AVTP Production Video Format (APVF) Stream Packetization Proposal

v1b 3-Dec-2012

Notes taken during 1722a Working Group F2F meeting appear in green bold text

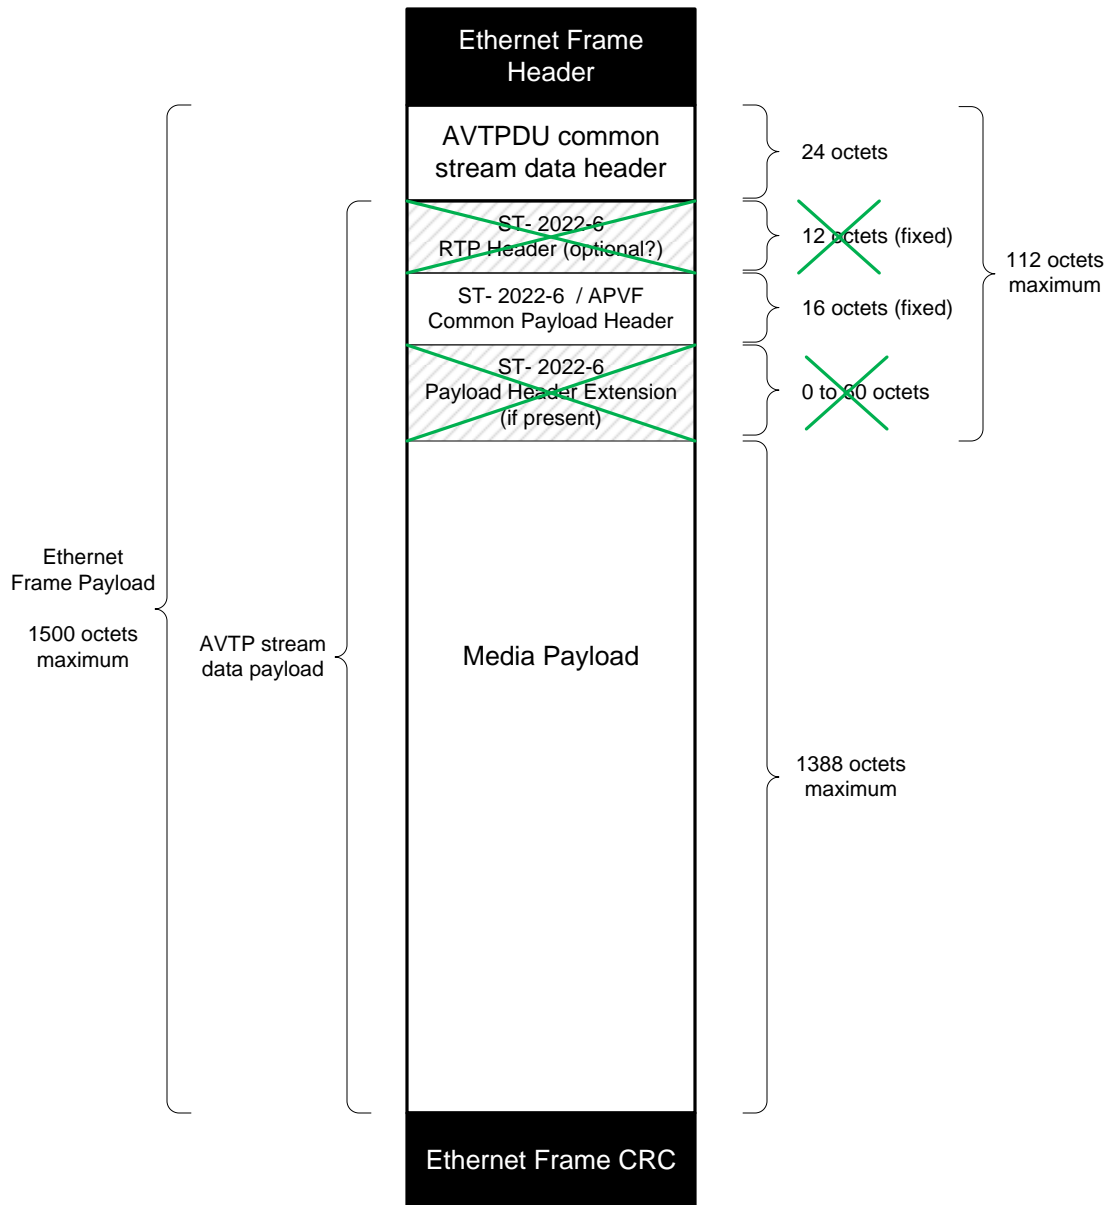
it was suggested for the P in this acronym to stand for "Professional" instead of "Production"

Figure 5.3 – AVTP common stream header format (cd field set to zero (0))

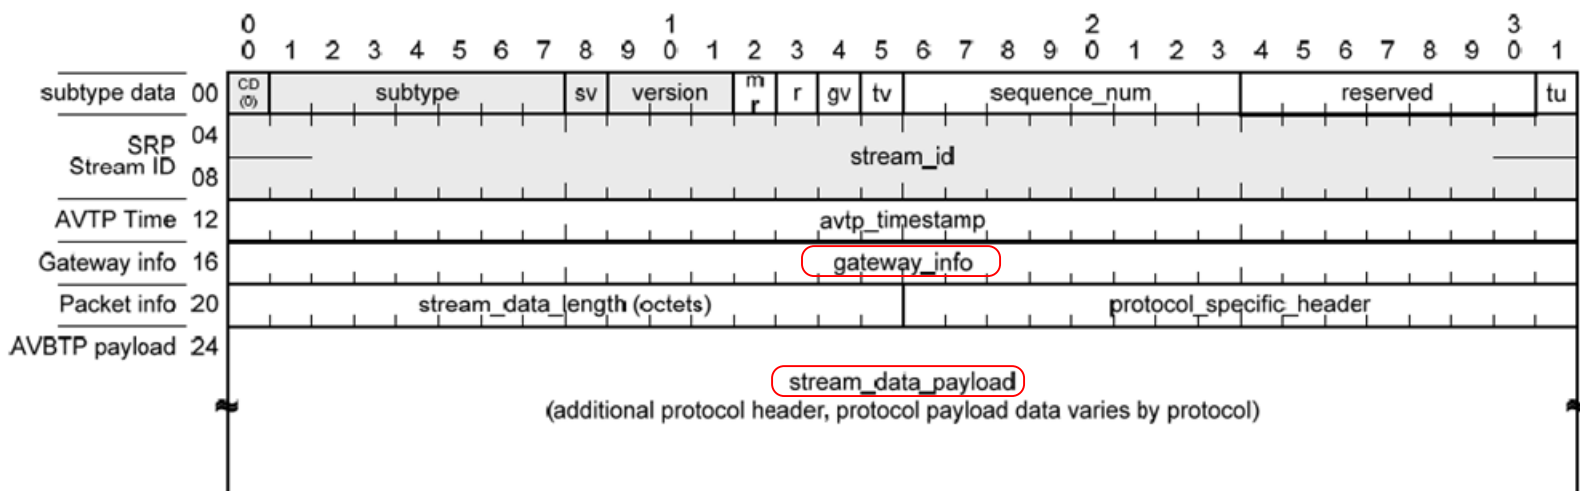
- **mr** (media clock restart): 1 bit
- **r** (reserved): 1 bit
- **gv** (gateway_info valid): 1 bit
- **tv** (avtp_timestamp_valid): 1 bit
- **sequence_num** (sequence number): 8 bits
- **reserved**: 7 bits
- **tu** (timestamp_uncertain): 1 bit
- **avtp_timestamp**: 32 bits
- **gateway_info**: 32 bits => re-defined as "Format info" in 1722A, AVTP Audio format
- **stream_data_length**: 16 bits => conveys length of AVTP payload, including ST2022-6 headers
- **protocol_specific_header**: 16 bits => see fields defined on later page
- **stream_payload_data**: 0 to n octets (where n does not cause the packet to exceed the MTU)
 - denoted as "stream_data_payload" in Fig 5.3 (we should correct this in 1722A)

Is there any applicability for "gateway info" in AVTP video considering the desire to easily bridge APVF to/from SMPTE 2022-6 streams carried over IP or WAN networks?

=> 1722a working group consensus: No, we should not use this for APVF. This field was defined for bridging between 1722 and 1394 (Firewire) and is not in use by any relevant implementations, according to all meeting participants. If we do choose to create header info for bridging between APVF and ST 2022-6, we should define a completely new field for this.

Figure 2. RTP Header

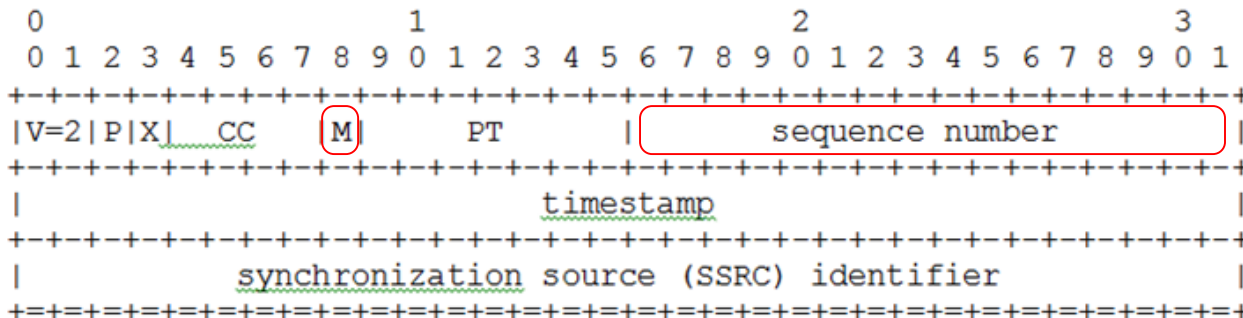
Not required to be supported. If not supported, should be zero-stuffed.

We could define a “ST2022-6 info” field in APVF header, which could indicate whether this field is valid or not.

shall we consider this EOF bit optional, and use in in this RTP header field only? Or do we want to have an EOF bit for AVTP Production Video streams that do not carry RTP header?

=> due to payload length differences between APVF and AAF, this sequence number, if used, will skip or repeat values in APVF

1722a Working Group consensus: Do not include this header in APVF. People who want to carry RTP video in AVTP should use the “RTP payloads” format under AVTP, instead of APVF.

Figure 3. Payload Header

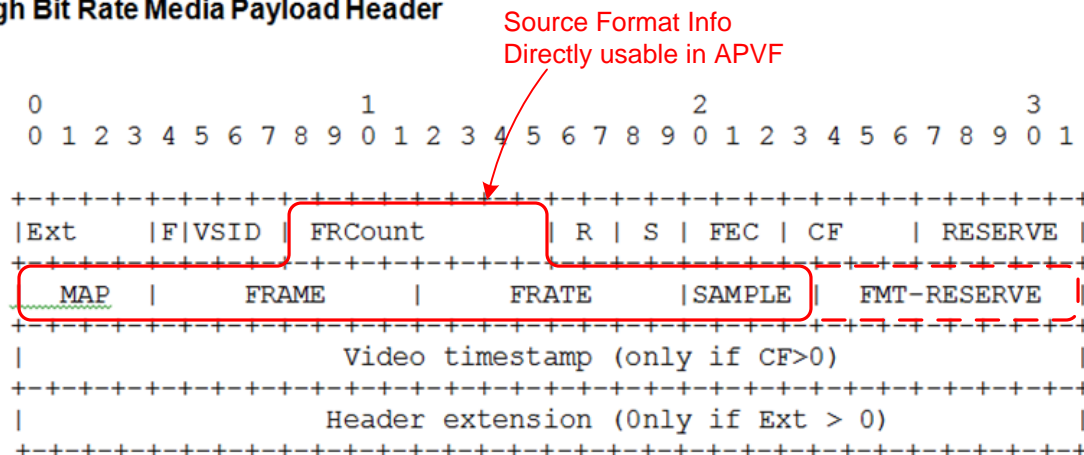
Extension field: (Ext) 4 bits *required for SMTPE and APVF (must match media_data_offset in AVTP header)*
“0000” = No extension
“0001- 1111” = Payload header is extended by this number x 4 octets

required for SMTPE and AVTP-PVF

Video source ID (VSID) Protection profile: 3 bits *optional for AVTP-PVF*
Set to 000 - primary stream
Set to 001 - protect stream
010-111 - reserved

Frame Count (FRCCount): 8 bits *required for AVTP-PVF*
This field identifies a video frame counter value. The counter shall increment to a new value for the next RTP sequence numbered datagram immediately after the end of video frame M marker bit and shall roll over after 256 frames.

Reference for time stamp (R): 2 bit *not required / not used when SMPTE-2022-6 usage is FALSE*
Specific reference to the source of the time stamp
Set to 00 - not locked
Set to 01 - reserved
Set to 10 - locked to UTC time/frequency reference
Set to 11 - locked to a private time frequency reference

FEC field *FEC is disallowed (not supported) in AVTP-PVF*

Video timestamp (sampling instant of first data in this packet) *unlikely to be useful, due to payload size differences between APVF and 2022-6*

1722a Working Group consensus: Only use the Source Format Info fields and nothing else from this header. In particular, having this different timestamp field in the packet will likely confuse implementers more than it will help them.

Figure 9.1. AVTP Video PDU format

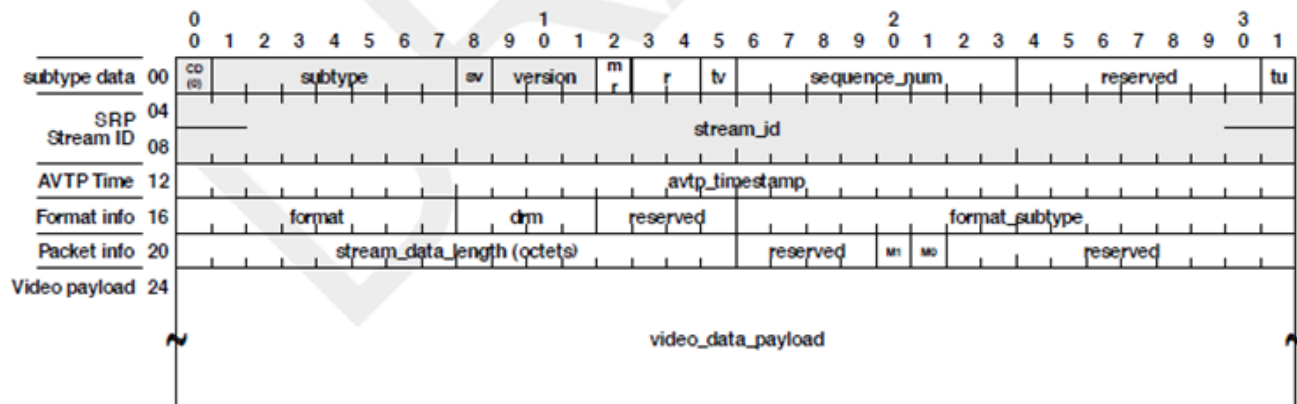
- `format` field: 1 octet <= use the value 0x01 for APVF (formerly assigned to raw sensor video which is no longer supported)
- `drm` field: 4 bits <= `drm` field is no longer used in latest 1722a definition
- `format_subtype` field: 2 octets
